DEVELOPMENT ASSESSMENT REPORT	
Application No.	DA/2020/0163
Address	279 Annandale Street ANNANDALE NSW 2038
Proposal	Alterations to existing dwellings on site and Torrens title subdivision into two lots
Date of Lodgement	10 March 2020
Applicant	Pamela Freeman
Owner	Inner West Council Mr Stephen Hart Ms Pamela E Freeman
Number of Submissions	Nil
Value of works	\$240,000.00
Reason for determination at Planning Panel	Clause 4.6 variation exceeds 10% (FSR and Subdivision Lot Size)
Main Issues	<ul style="list-style-type: none"> • Non-compliance with Subdivision Lot Size development standard. • Impact to Heritage Conservation Area
Recommendation	Approval with Conditions
Attachment A	Recommended conditions of consent
Attachment B	Plans of proposed development
Attachment C	Clause 4.6 Exception to Development Standards
Attachment D	Statement of Heritage Significance of Heritage Conservation Area

This report is an assessment of the application submitted to Council for alterations to existing dwellings and Torrens title subdivision into two lots at 279 Annandale Street, Annandale.

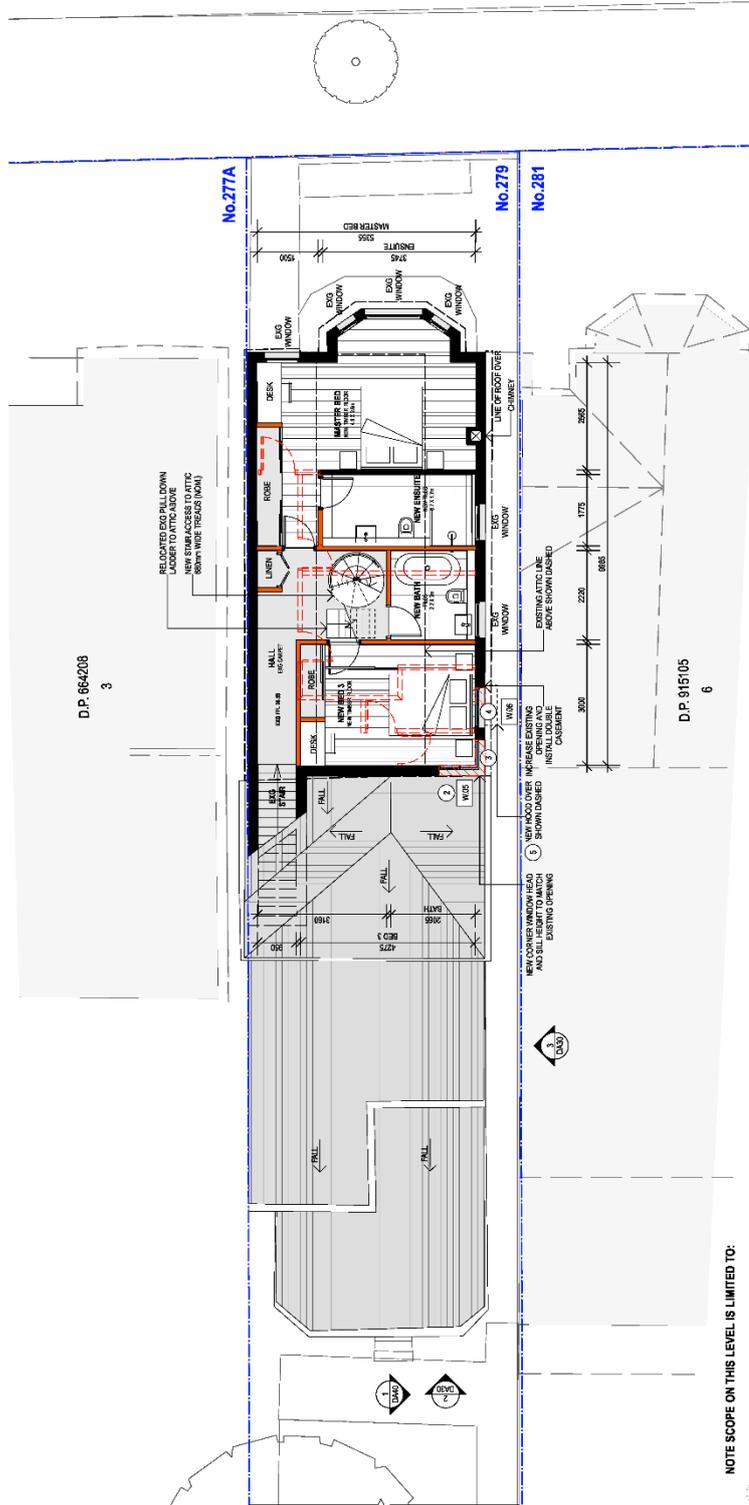
Comment: No change. The applicant is encouraged to retain the existing layout of the first floor to comply with C3 a. of Part C 1.4 of the DCP. As the changes are internal, they will not be visible from the public domain and will not impact on the streetscape or the heritage significance of the Annandale HCA.

Drawing Name: ADDITIONAL ELEVATIONS (PIPER LANE STUDIO)

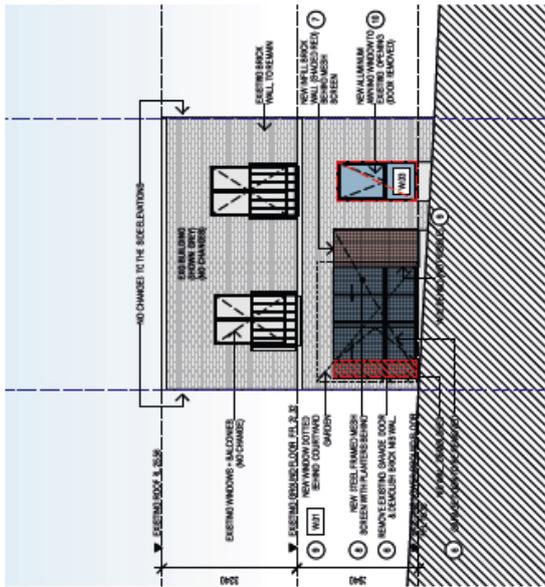
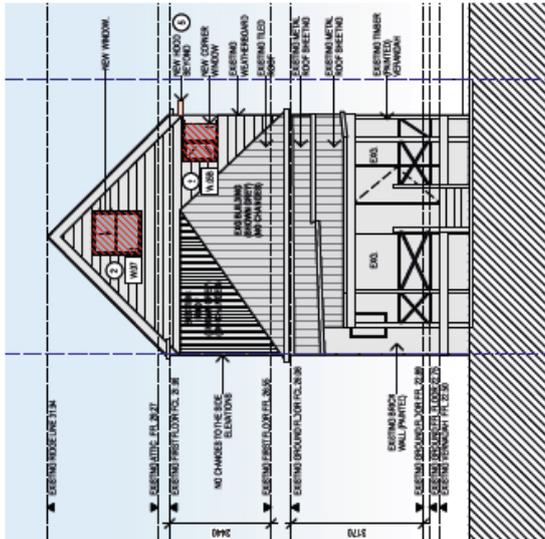
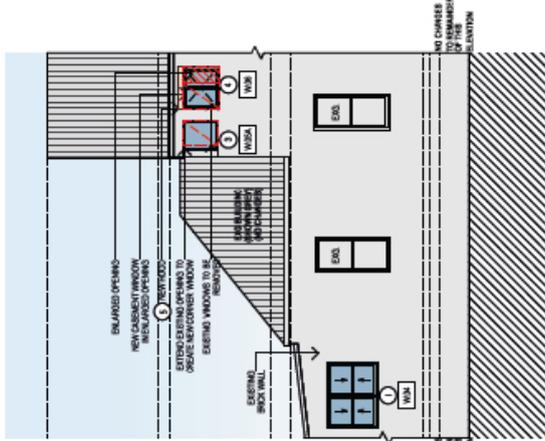
Clarify materials of the east elevation (rear) of the main dwelling in a larger scale East elevation with full notations of materials (proposed and existing) with existing photographs.

Comment: Provided. Proposed windows are timber framed.
